Appendix: HAL-NC/G1/2023/001 Heathrow Terminal 4 Platform 1 Approach speed change

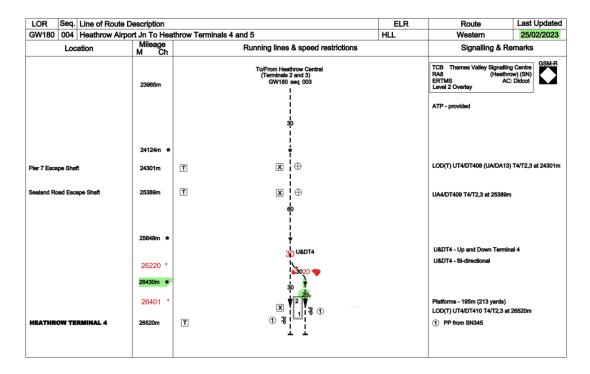
The Proposed Network Change would update the published line speed in respect of the approach to platform 1 at the Terminal 4 station in the Sectional Appendix, from 30mph to 20mph, and provides only for the addition of a speed board to advise drivers of the 20mph line speed. Currently all connected ETCS fitted units have their onboard systems restricted to 20mph.

The changes made in the marked-up diagram above reflect the change in speed from 30mph to 20mph at 26220m on the Terminal 4 Platform 1 Line, together with the addition of a new speed board.

To update the published line speed in respect of the approach to platform 1 at the Terminal 4 station in the Sectional Appendix, as marked-up in the diagram in paragraph 4 below, from 30mph to 20mph, and to add a speed board to advise drivers of the 20mph line speed.
